# Addendum Number 01

To Drawings and Specifications dated March 10, 2024

**2024 Watkins & Rowe MS and Cy Park HS Renovations**  
**Cypress Fairbanks Independent School District**  
**CFISD Proposal Number: 24-02-5753-R-RFP**

PBK Project No's.: 240058/240059

08 ART - NORTH ELEVATION  
1/4" = 1'-0"

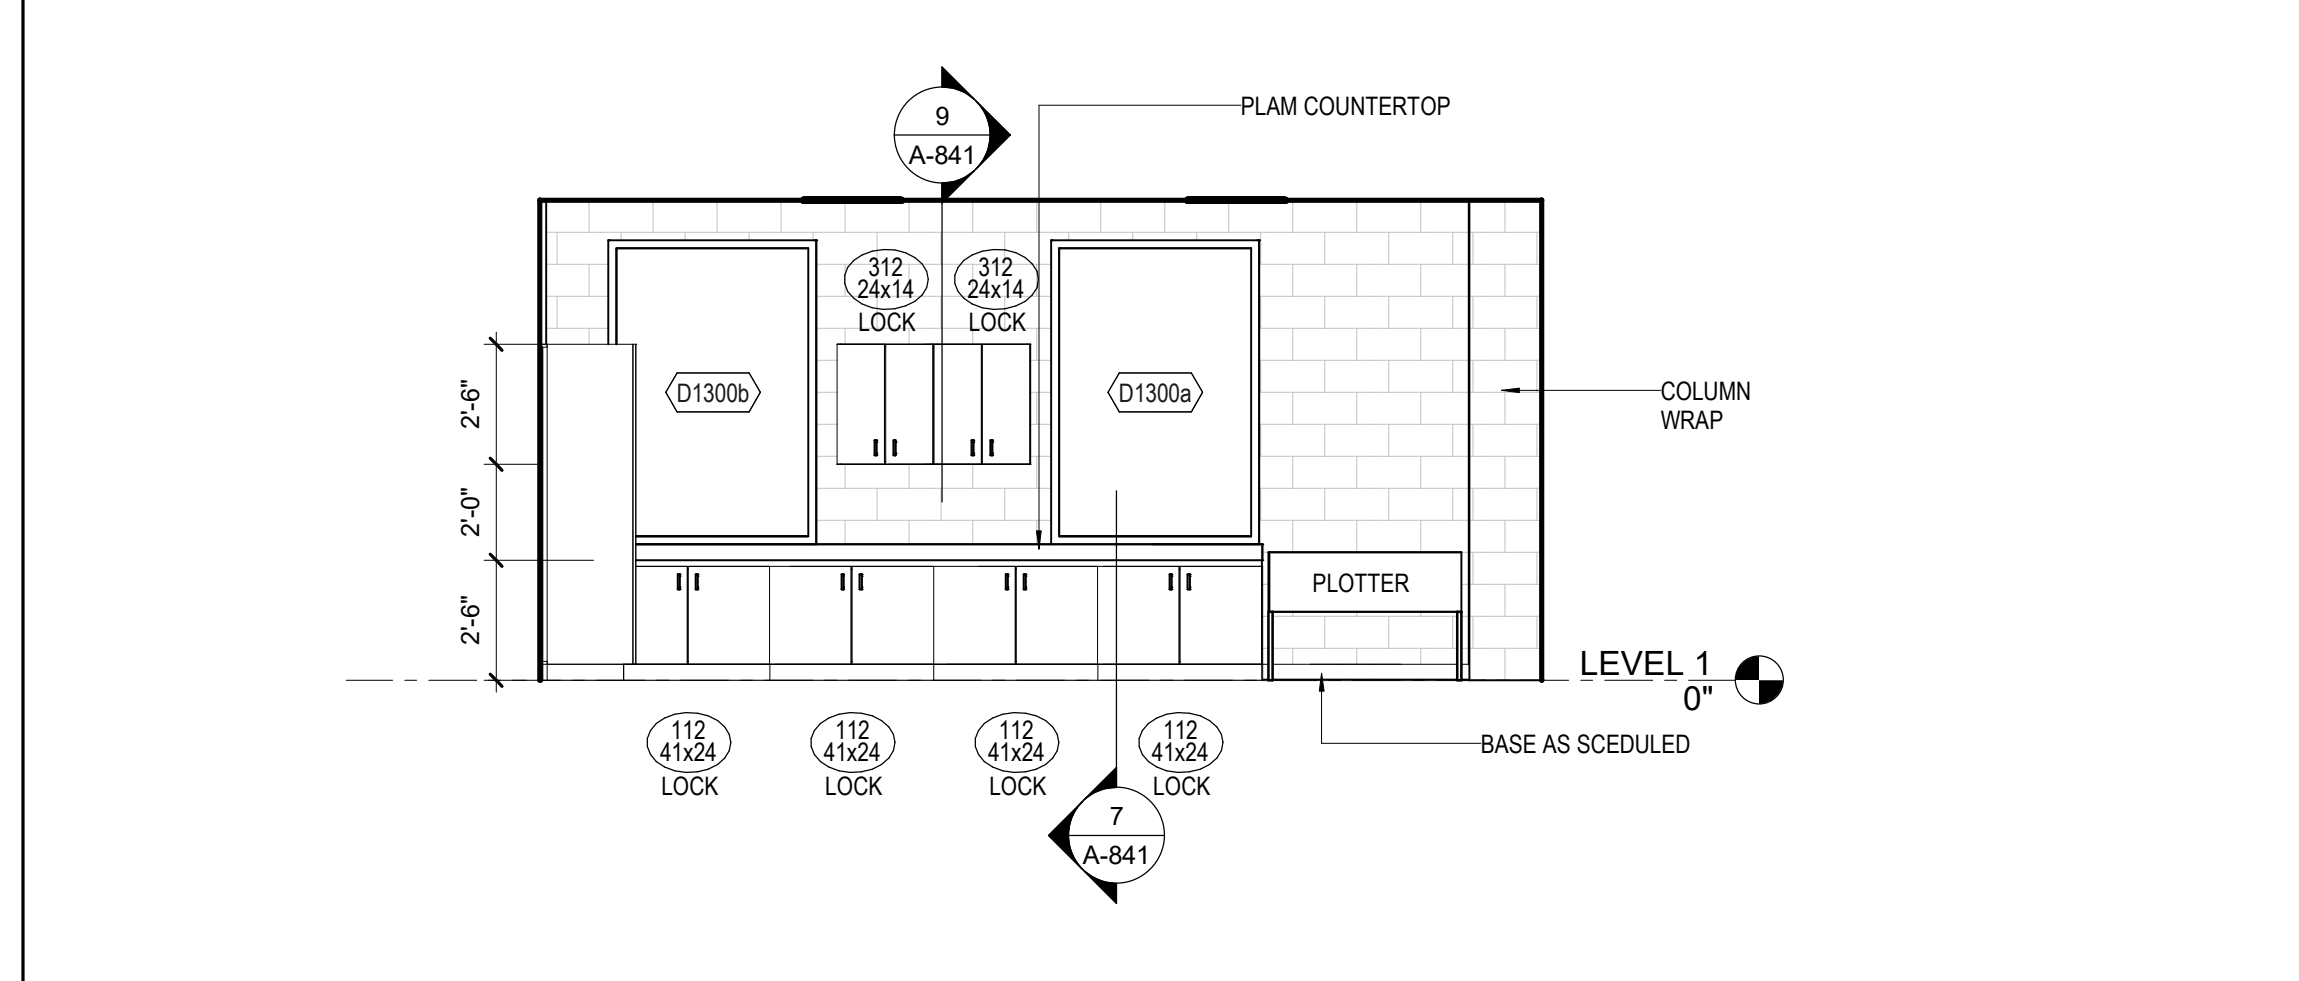
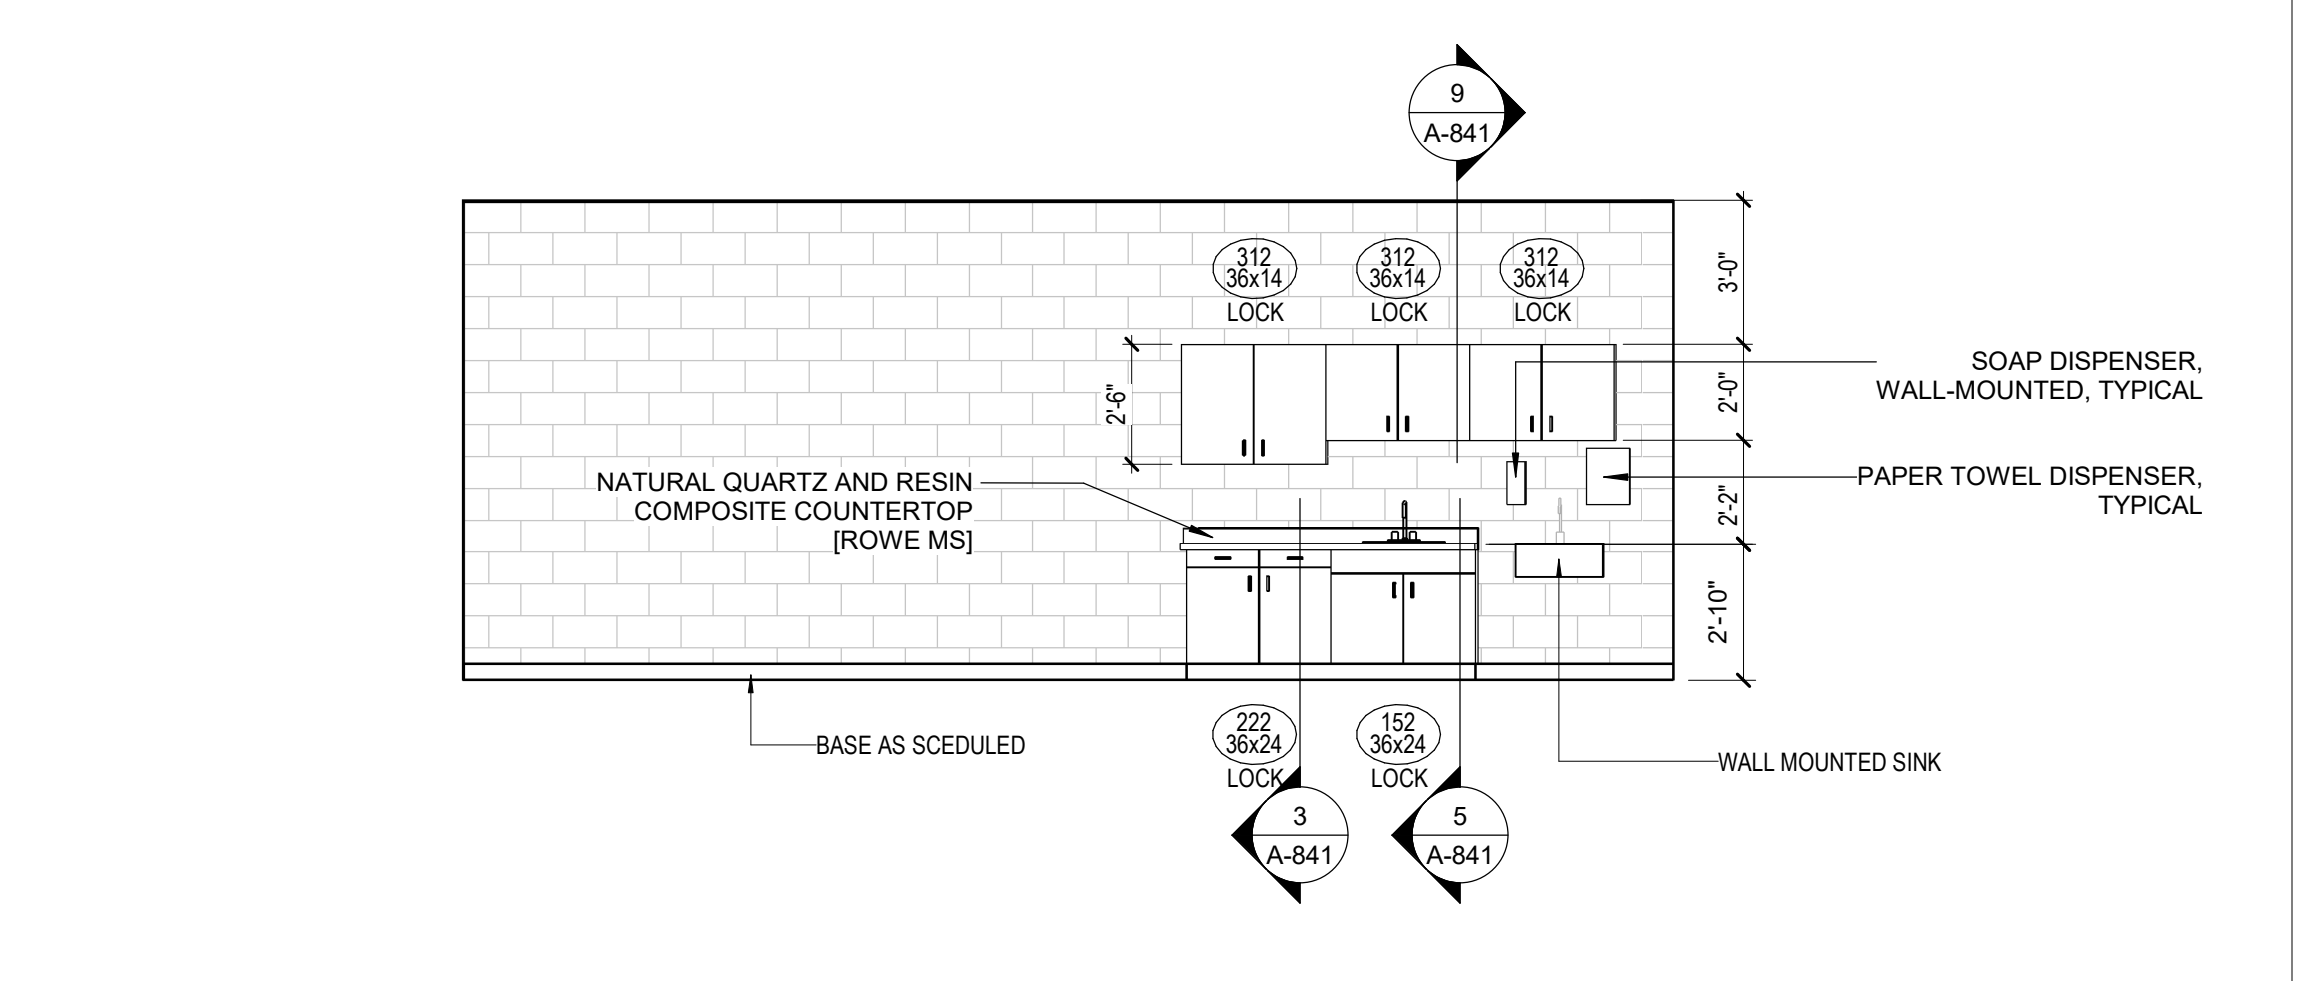
A. Detail 8 Art- North Elevation, revised locker count and width.

**2 MECHANICAL ENLARGED FLOOR PLAN - LEVEL 1 - MECHANICAL L1372**  
Scale: 1/4" = 1'-0"

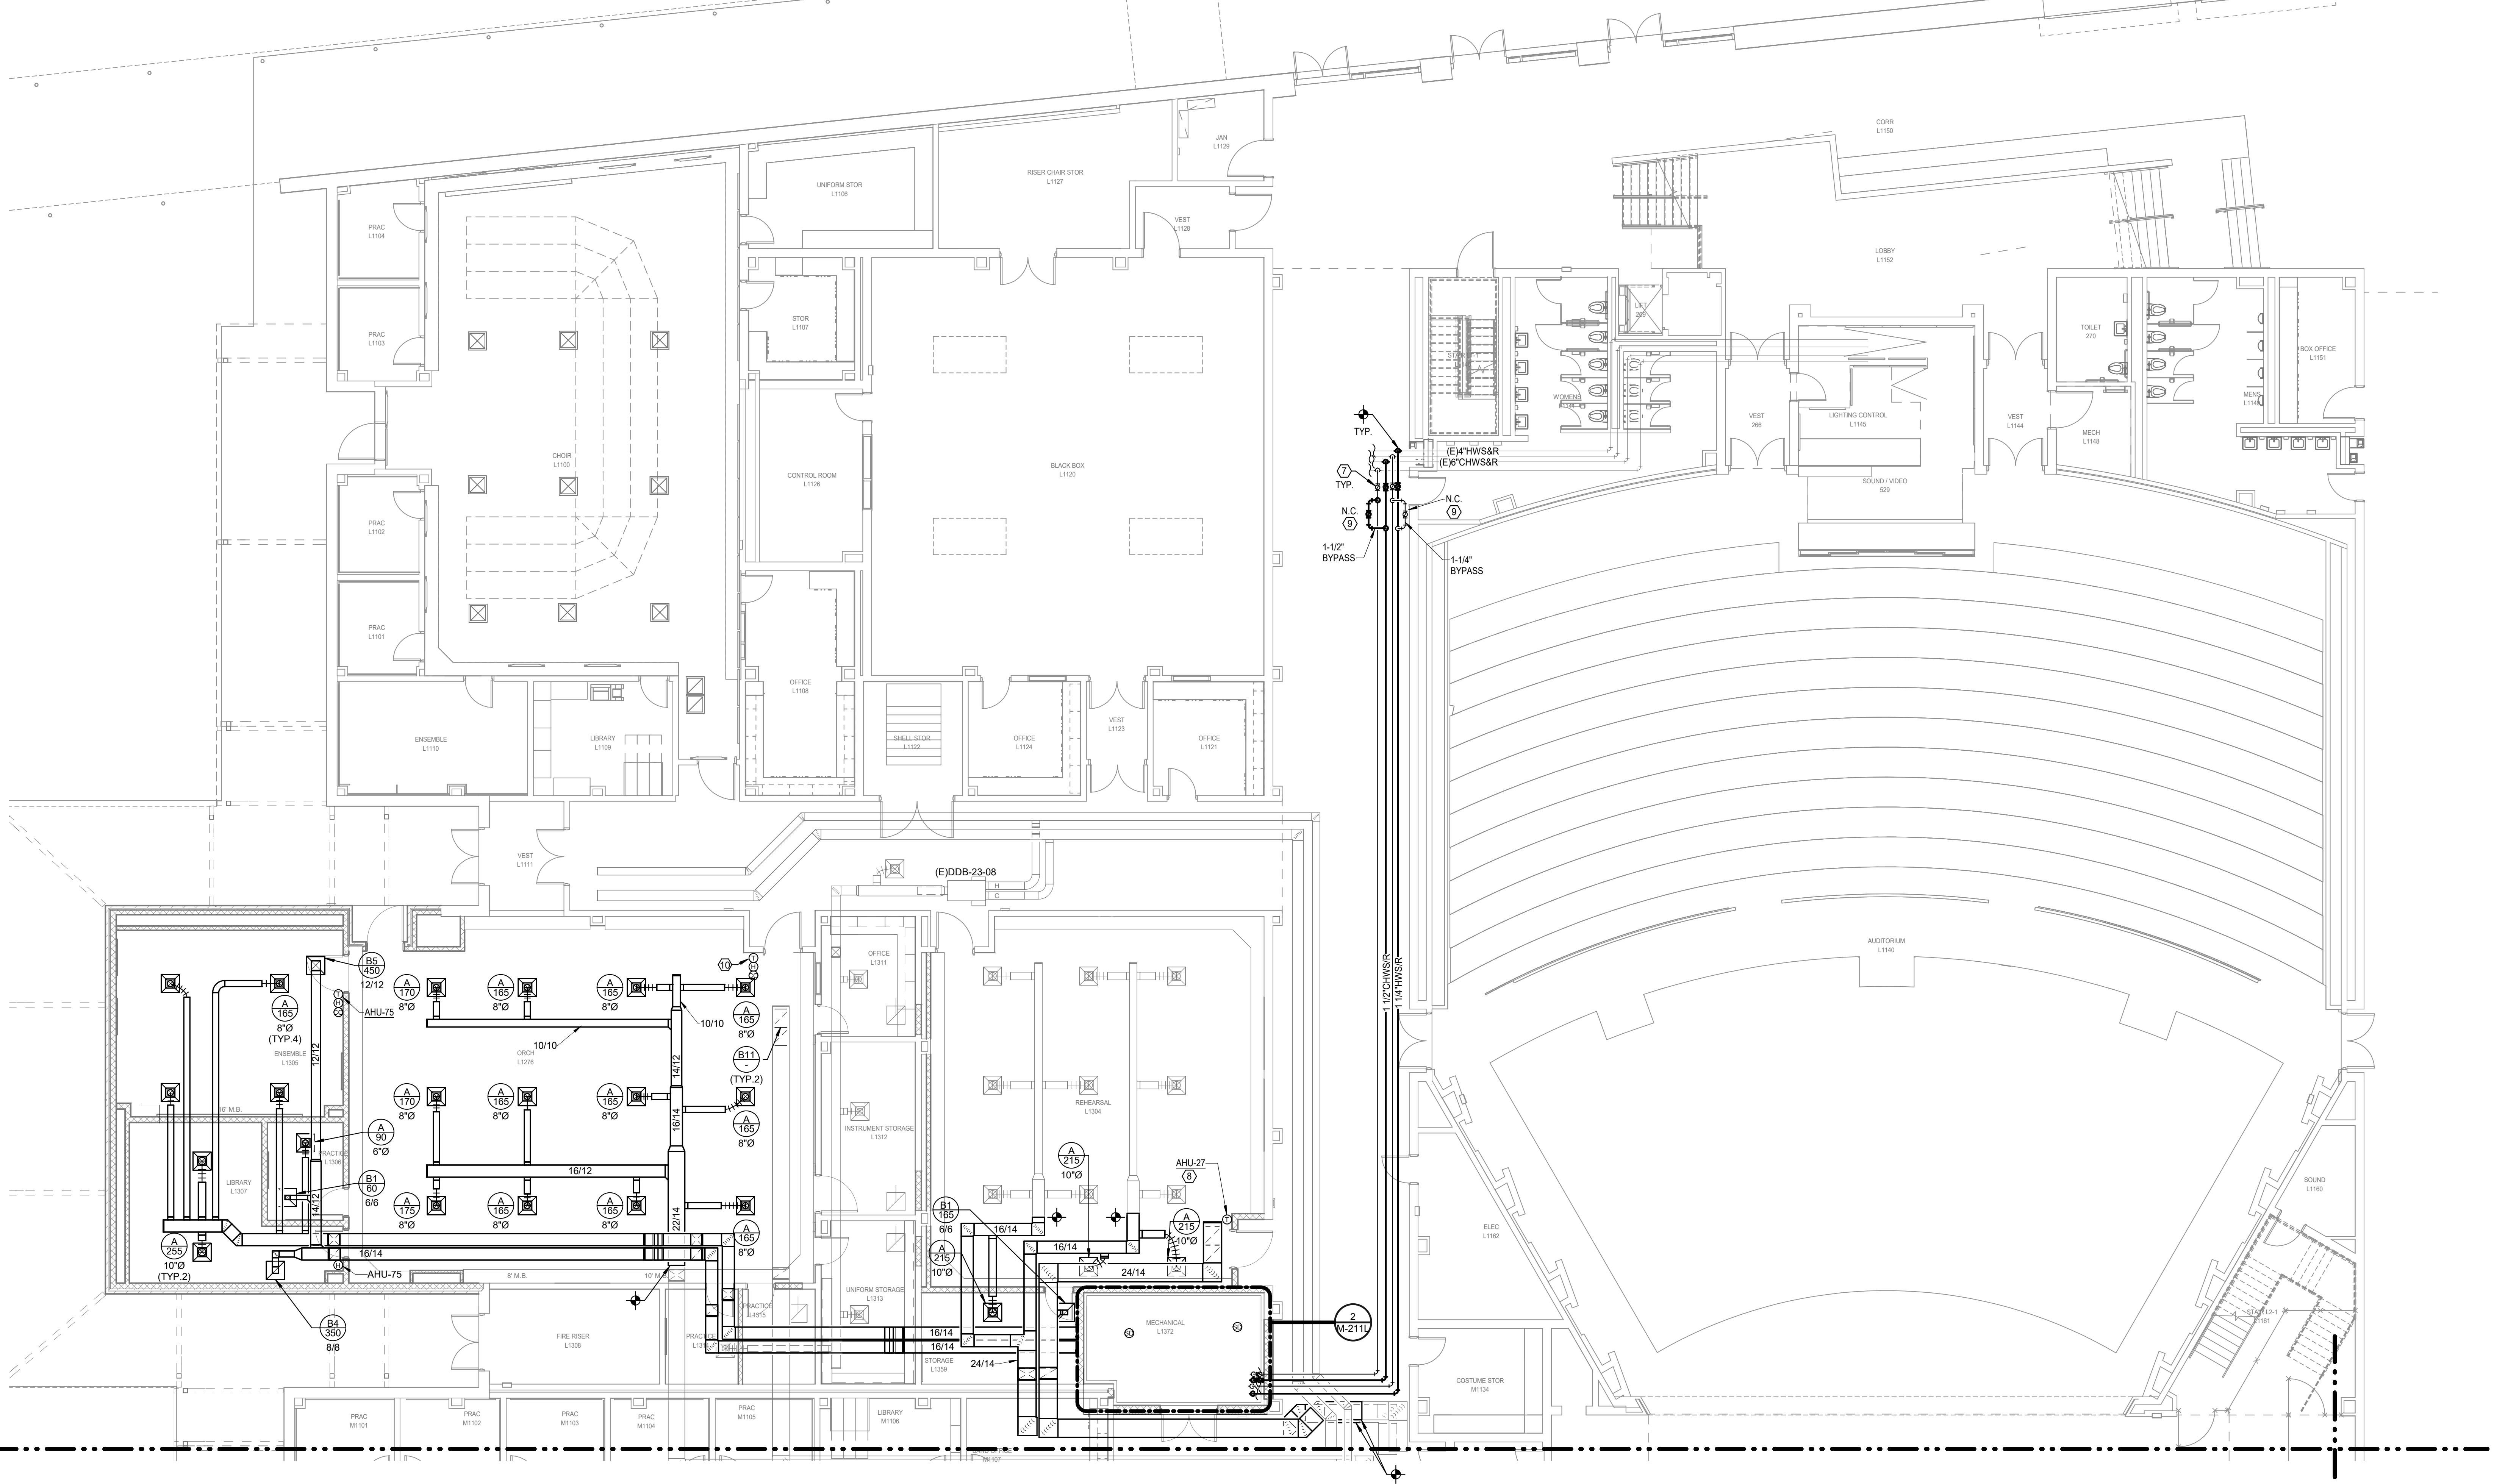
**Item No. 45** 2/M211L - MECHANICAL FLOOR PLAN - LEVEL 1 - AREA L  
A. Mechanical L1372, add smoke detectors.
